# **RESPONSE TO SUBMISSIONS AND PREFERRED PROJECT REPORT - SANTA SOPHIA CATHOLIC COLLEGE (SSD\_9772)**

20 SEPTEMBER 2019  
P0001299  
FINAL  
PREPARED FOR CATHOLIC EDUCATION DIOCESE OF PARRAMATTA

Figure 2 – Height Plane –Surrounding Development Context

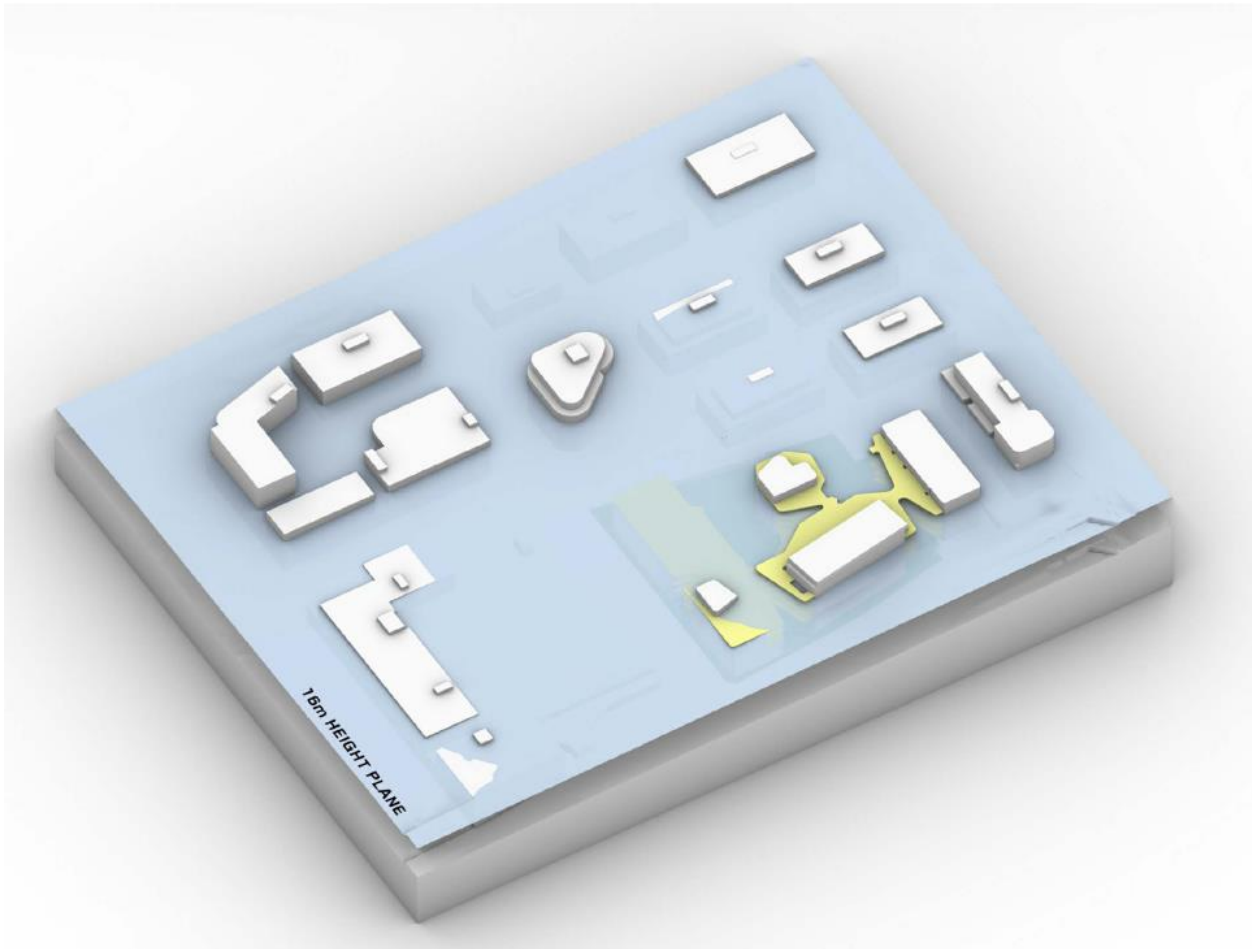
Matter	Comment	Response	Refer to
<b>The Hills Shire Council</b>			
Height	<p>It is considered that the planning proposal is not considered imminent or certain and therefore should not be relied upon in justifying the height contravention.</p> <p>DA 1542/2019/ZB proposes to cut the roads that surround the school by 2m – 3m resulting in the actual building height being 29.5m above the future finished grounds levels.</p> <p>Council noted that the justification of the height contravention appears deficient.</p>	<p>A meeting was held between Council, CEDP, TSA Project Management and Urbis on 13 August 2019 to discuss. The outcomes of this meeting are referred to throughout this table, and meeting minutes have been provided with the RtS.</p> <p>The exhibition of the Planning Proposal ended on the 28 August 2019. Timeframes for the gazettal of the Planning Proposal are unknown. Notwithstanding this, the Planning Proposal provides a strong indication of the future context surrounding the college site and a relevant consideration when considering the appropriateness of the proposed height of the school.</p> <p>Additional justification for the height variation has been prepared in accordance with Clause 4.6 framework as requested by DPIE. This includes solar analysis and contextual analysis of the proposed building height as requested by Council.</p>	<p>Refer to <b>Appendix G</b> for Council meeting minutes.</p> <p>Refer Section 3.2 and height variation request at <b>Appendix E</b>.</p>

The maximum height of the school will be 29.9m above ground level. While the planning proposal (PP\_2018\_THILL\_012\_00) is undetermined, the proposed building heights and typologies proposed across the town centre do provide a strong indication of the future surrounding building form. For the sites immediately to the south and to the east of the college site, the proposed maximum building height is 27m. The proposed height of the college will therefore be in keeping with the modulation of building heights sought across the town centre (refer Figure 2 below). The adjacency of the proposal to the future town centre also means that the building will appear of an appropriate and suitable scale in its immediate context.

Figure 3 – Shadow Diagrams – Mid Winter

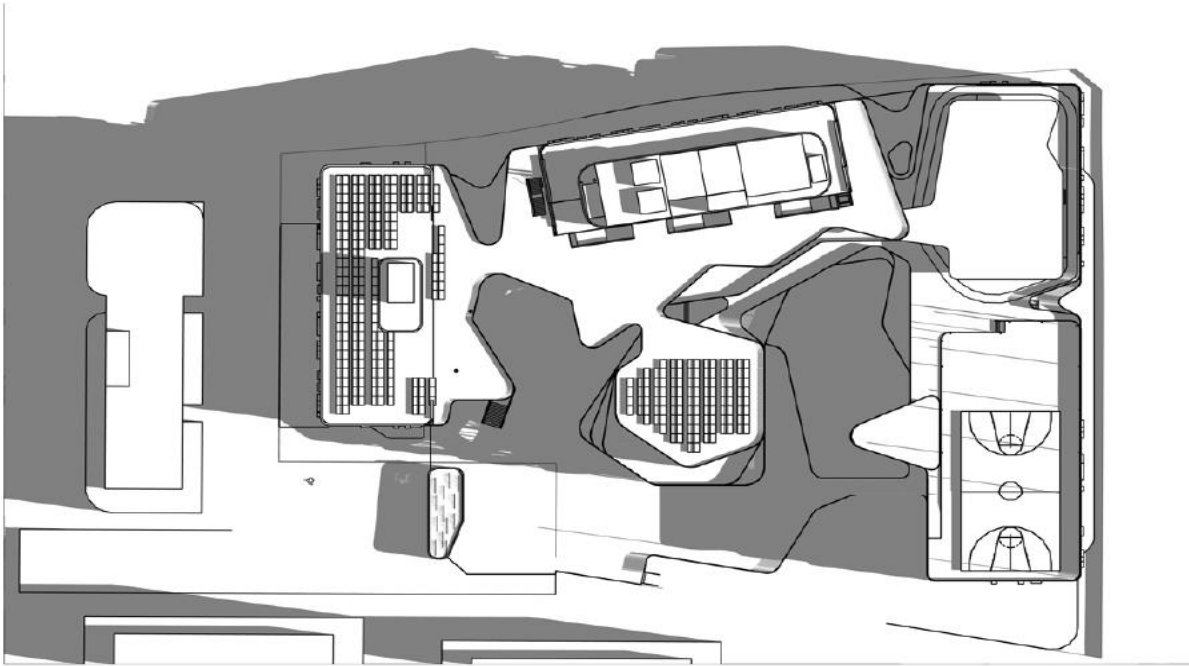
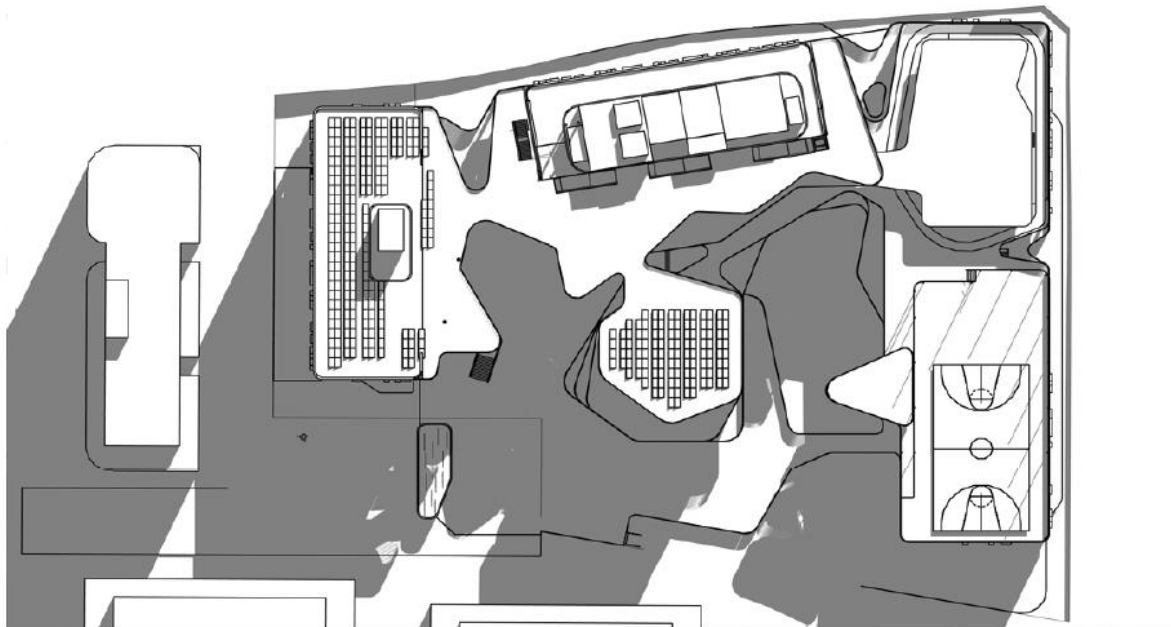
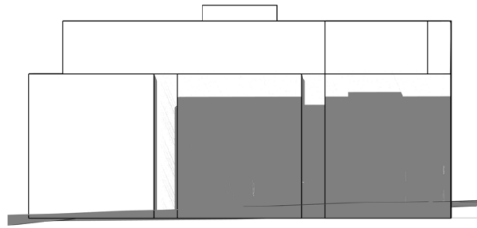
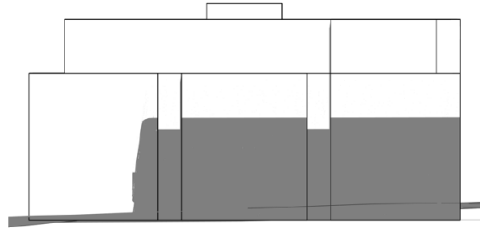
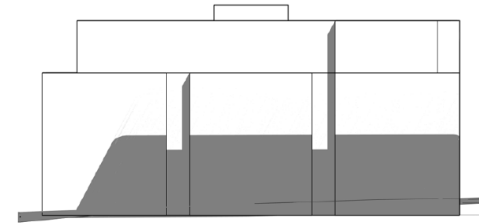
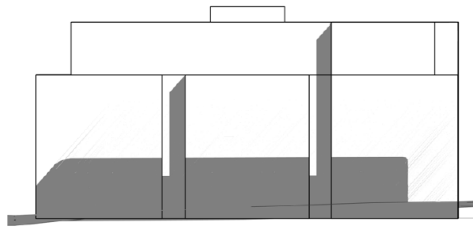
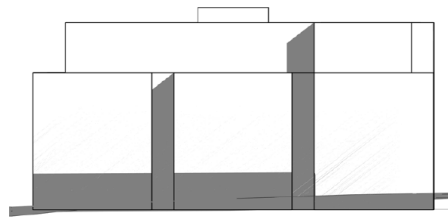
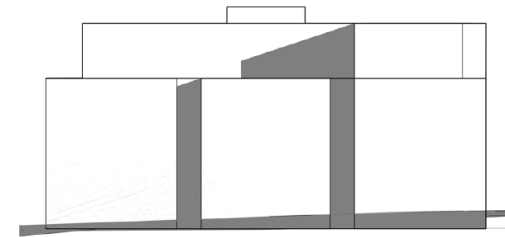
Residential Amenity - Overshadowing	The proposed southern school building would have overshadowing impacts on the future residential apartment building adjacent to the site. During winter months some lower level apartments may receive less than 2 hours of sunlight during the day. As a result, any future residential development would be unable to meet the requirements of State Environmental Planning Policy No 65 - Design Quality of Residential Flat Development in relation to solar access. This is a poor design outcome for a greenfield development site and the proposal must be redesigned to give appropriate consideration to the overshadowing impacts to future adjoining residential development.	Refer to section 3.2.2 of the RTS report for further details on shadow impacts to building 4F.	Refer to Section 3.2, <b>Appendix C.1</b> and <b>Appendix E.</b>

- The massing of the southern school building has been organised such that the southern-most edge of the adjacent building will receive solar access throughout the day. BVN has also undertaken master planning co-ordination with the neighbouring development to the south to understand their future design intent. As the design of the neighbouring building to the south is yet to be finalised, there is an opportunity for the future design to respond to these conditions, for example by locating the living areas of this building away from the southern façade
- The elevation study demonstrates that the north-eastern façade of Building 4F will receive the minimum solar access for residential apartments as outlined by the NSW Apartment Design Guide.
- A portion of shadow will be over the adjacent public domain.

Figure 4 – Secondary Pickup Dropoff

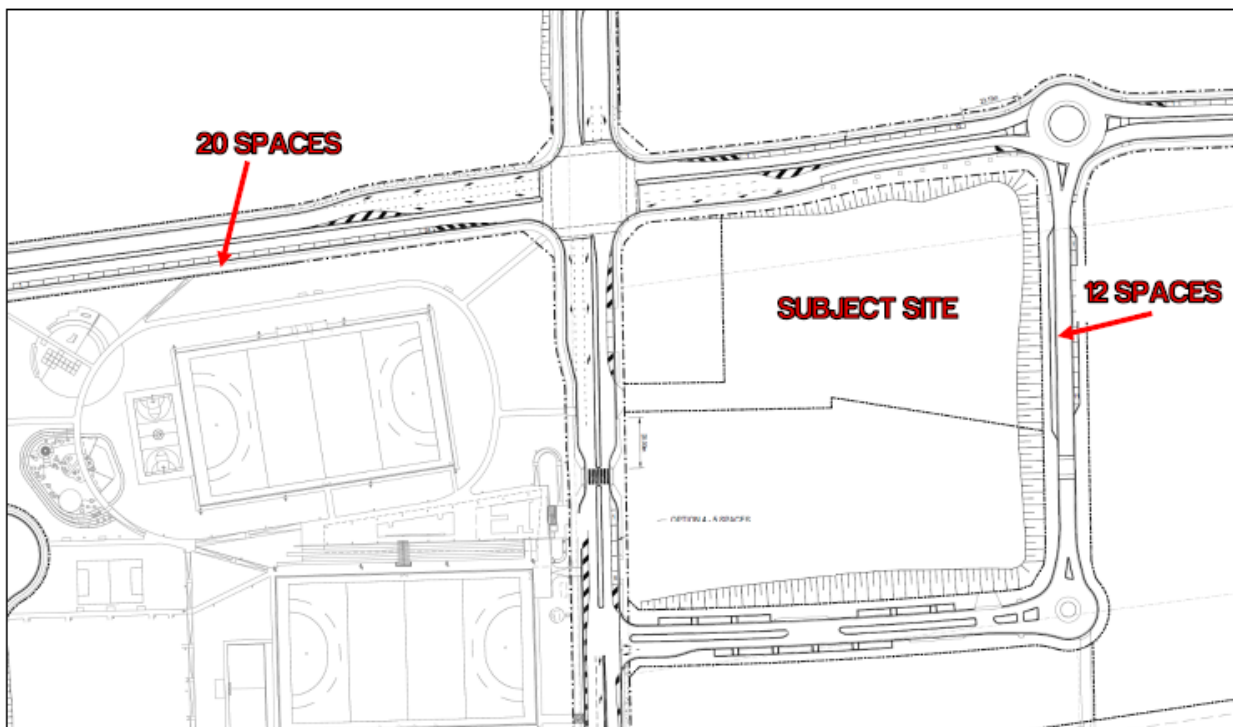
Matter	Comment	Response	Refer to
	limited opportunities for on-site parking/availability of public transport.	out of school hours. Council were satisfied with the proposed parking arrangements.	
Pick-up/Drop-off	Council have also noted that once the school reaches full capacity the pick-up/drop-off area will not suffice. Further measures are recommended to support student pick-up/drop-off.	Pick up and drop off was discussed in the meeting with Council. Ason Group has undertaken an assessment of the pick-up / drop-off demand considering the yearly student population increase for the School. This showed that by 2023, Santa Sophia would require additional kiss and drop capacity. Celestino and CEDP will provide an additional 20 spaces along Fontana Drive, south of the intersection of Fontana Drive and Red Gables Road, adjacent to the hockey fields. This additional pick up/ drop off area would be for secondary school students, while the Road B pick-up / drop-off area would be dedicated for the primary school only. The project team provided a plan of this additional kiss and drop area to Council on 21 August 2019 and this has also been provided with the RtS.	Refer Section 3.5 and <b>Appendix B.</b>

At full development in 2023, the capacity of the Road B pick-up / drop-off area would be exceeded using the trip generation rates detailed in the previous TIA. In this regard the pick-up / drop-off demand would exceed the capacity of the Road B pick-up / drop-off area. To address this demand, Celestino, and CEDP will provide an additional 20 spaces along Fontana Drive, south of the intersection of Fontana Drive and Red Gables Road, adjacent to the hockey fields. This additional pick up/ drop off area would be for secondary school students, while the Road B pick-up / drop-off area would be dedicated for the primary school only.
